Meeting Minutes: Plumbing Board

D. Variance Petition, Oak-Land Middle School – Larson Engineering (Attachments B & C)

Re: Variance Petition
Oak-Land Middle School Additions Project
Lake Elmo, MN

To: Minnesota State Plumbing Board Date: December 10, 2024
From: Larson Engineering, Inc. Project No: 12246044
Project: Oak-Land Middle School Additions & Renovations
Re: Variance Regarding 2020 Minnesota Plumbing Code Section 310.5

PRIMARY EXTERIOR ISSUES

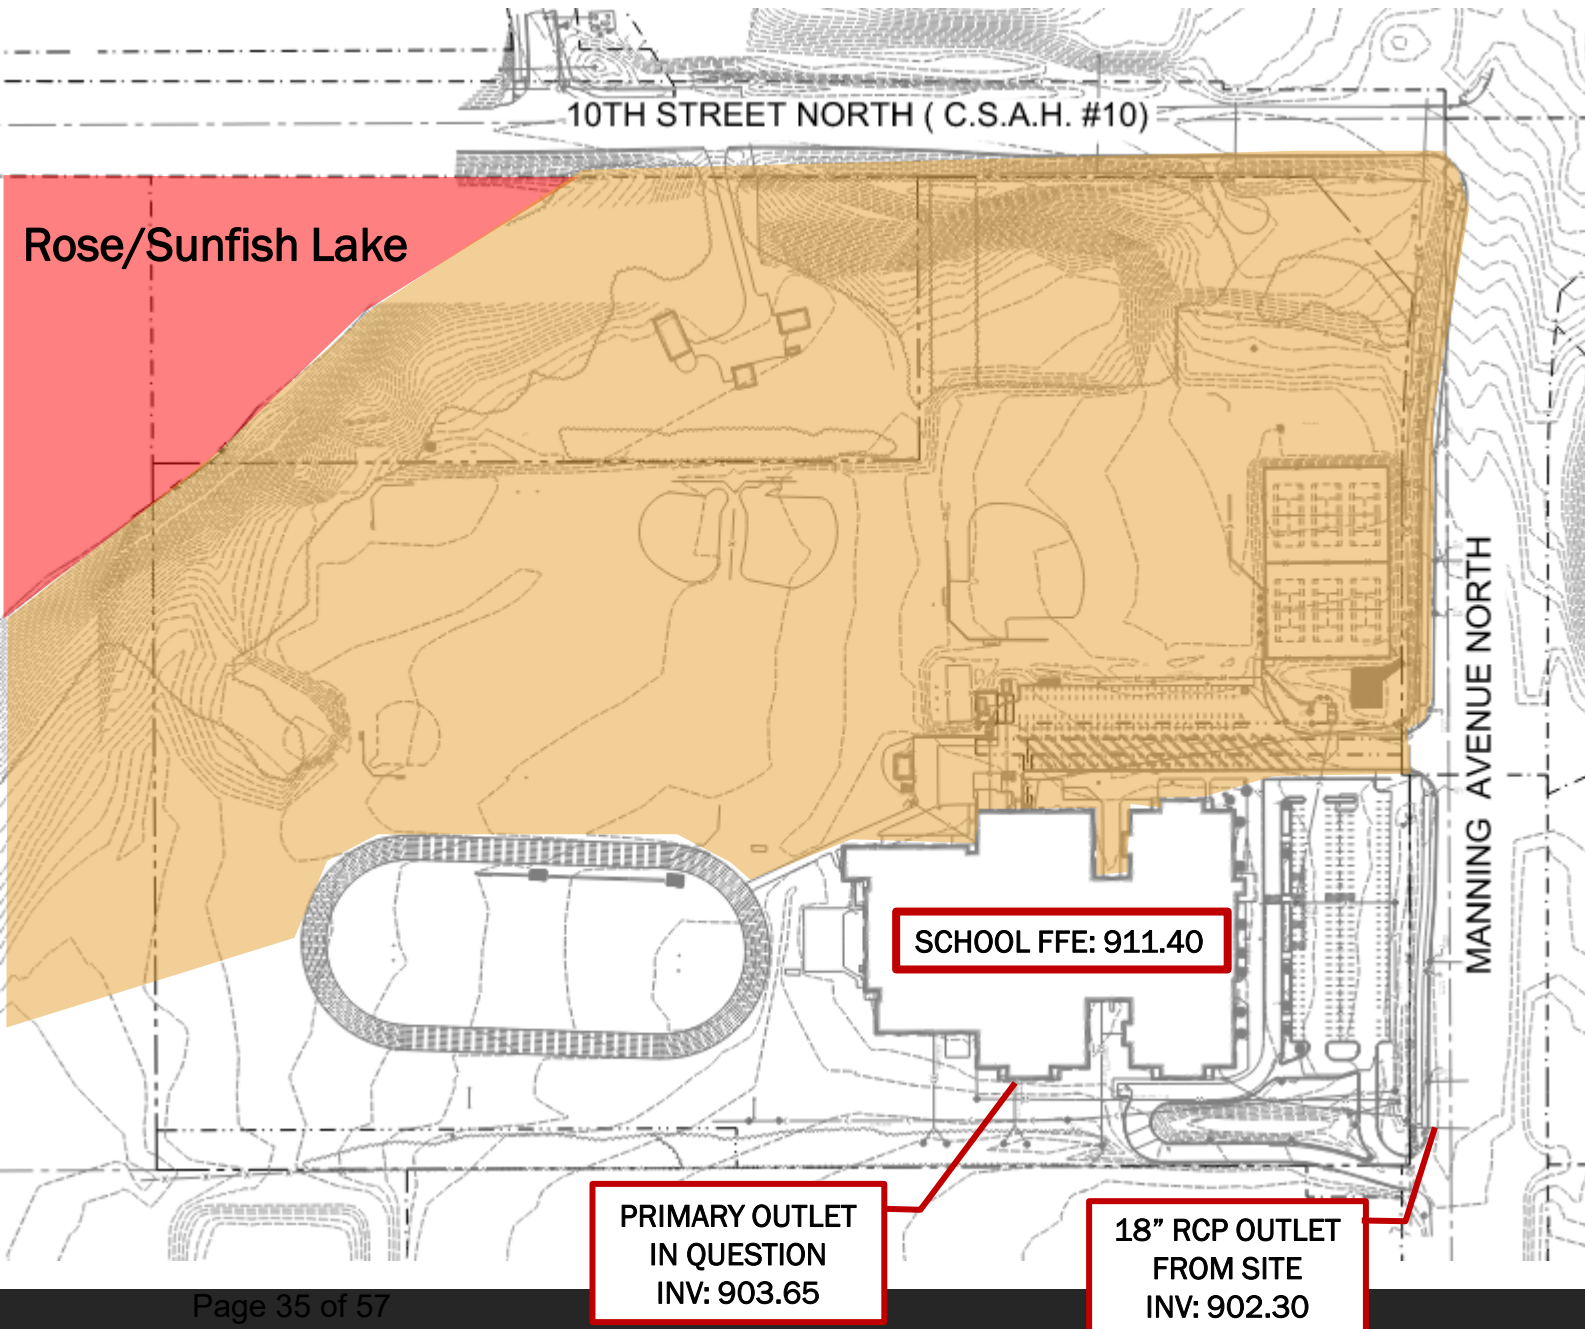
- EXTERIOR ELEVATION THE ROOF LEADER LEAVES THE BUILDING
 - BUILDING FINISH FLOOR ELEVATION = 911.40 (100' 00")
 - OUTLET ELEVATION = 903.65 (92' 3")
 - 7' 9" FROM FFE TO INVERT OF ROOF LEADER

- DRYWELLS WERE NEVER DESIGNED TO PROVIDE WATER QUALITY VOLUME.
 - CURRENT DRYWELL SERVICING THE ROOF LEADER IN QUESTION PROVIDES ROUGHLY 200 CF OF WATER QUALITY VOLUME (WQV) WHICH WOULD BE SUFFICIENT FOR A ROOF WITH AN AREA 2,400 SF

- LACK OF LOCATIONS ON SITE WITH LOW ELEVATION.
 - ROSE/SUNFISH LAKE WATERSHED: CAN'T INCREASE RATES OR VOLUME TO THE LAKE IN ANY STORM EVENT.
 - LOWEST GRADE AT SOUTH PROPERTY LINE = 906.00

- LOW STORM INVERT LEAVING THE SITE = 902.30
- POSSIBLE OUTLET LOCATION IS JUST OVER 500 FEET FROM EXISTING ROOF LEADER CONNECTION POINT

PROPOSED CONDITIONS IF VARAINCE IS APPROVED

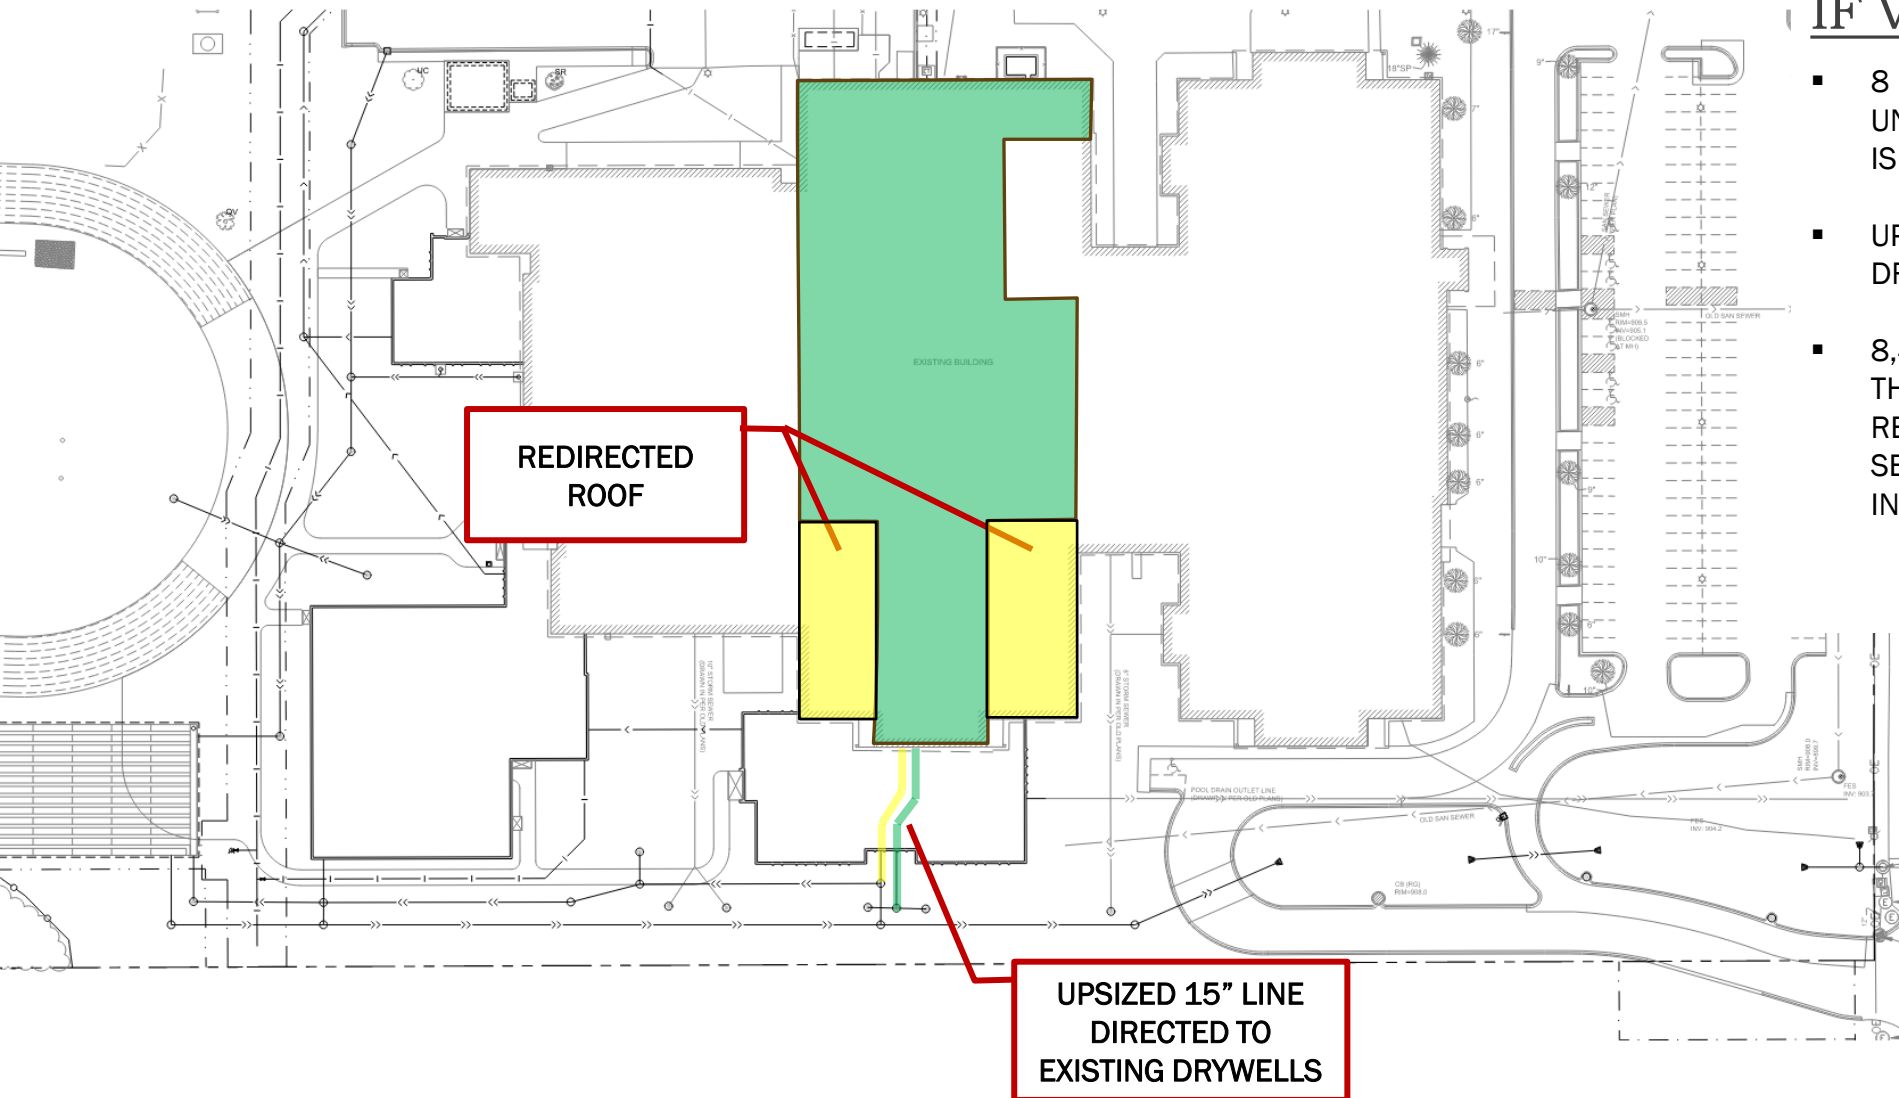
- 8 INCH VCP IS REVISED TO A 15 INCH PVC UNDER NEW ADDITION, DOWN STREAM PIPING IS ADJUSTED ACCORDNGLY
- UPSIZED PIPE CONNECTS BACK INTO EXISTING DRYWELLS
- 8,400 SF OF EXISTING ROOF THAT GOES TO THE EXISTING 8 INCH LINE WILL BE REDIRECTED TO A NEW ROOF LEADER SERVICED BY A NEW UNDERGROUND INFILTRATION SYSTEM.

PROPOSED CONDITIONS IF VARAINCE IS DENIED

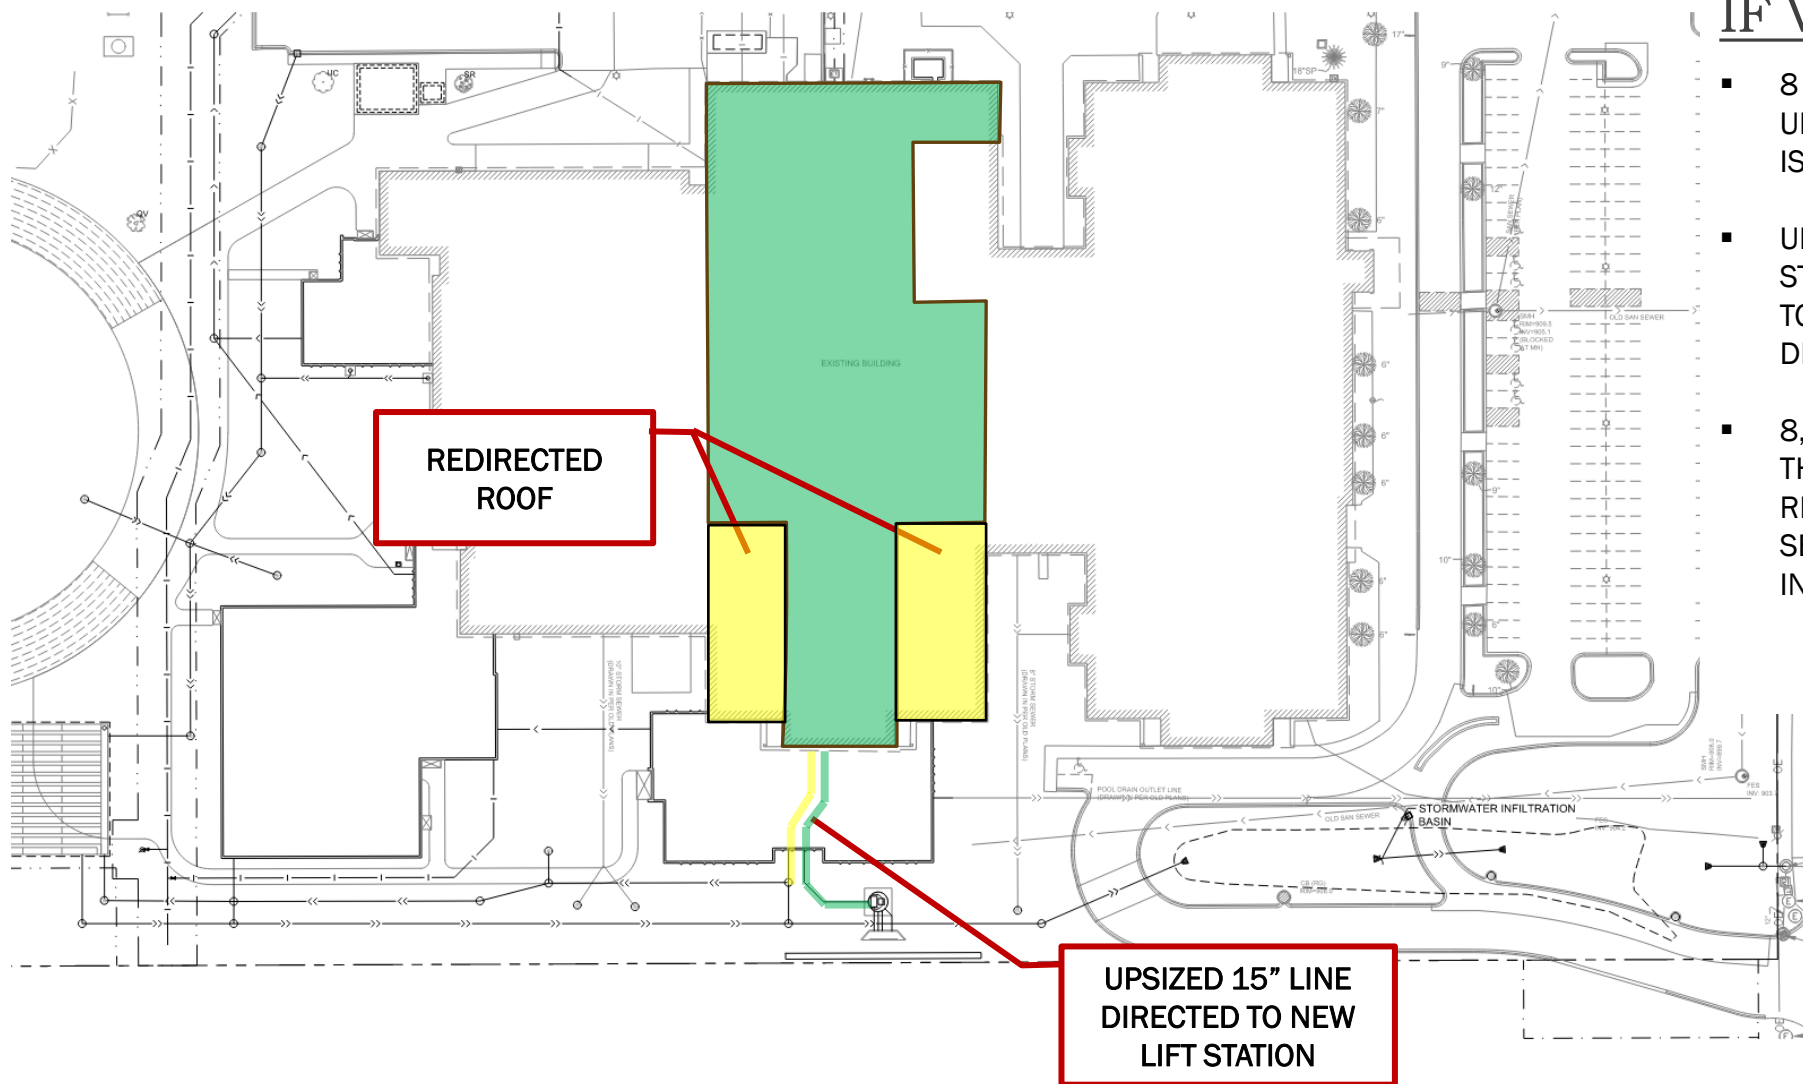
- 8 INCH VCP IS REVISED TO A 15 INCH PVC UNDER NEW ADDITION, DOWN STREAM PIPING IS ADJUSTED ACCORDNGLY
- UPSIZED PIPE CONNECTS INTO A NEW LIFT STATION STRUCTURE DESIGNED TO BE ABLE TO PUMP 2,900 GALLONS PER MINUTE AND DISCHARGES ON GRADE.
- 8,400 SF OF EXISTING ROOF THAT GOES TO THE EXISTING 8 INCH LINE WILL BE REDIRECTED TO A NEW ROOF LEADER SERVICED BY A NEW UNDERGROUND INFILTRATION SYSTEM.

A motion was made by Becker, seconded by Erickson, to deny the variance petition request for Oak-Land Middle School. As presented, there is an alternative approach designed using a lift station that would allow the piping to not be surcharged, complying with the code; therefore, even with the increased cost, this is not reason enough to allow the variance. The majority roll call vote ruled with 10 in favor, one against (Wahlen), and one abstention (Parizek); the motion passed.
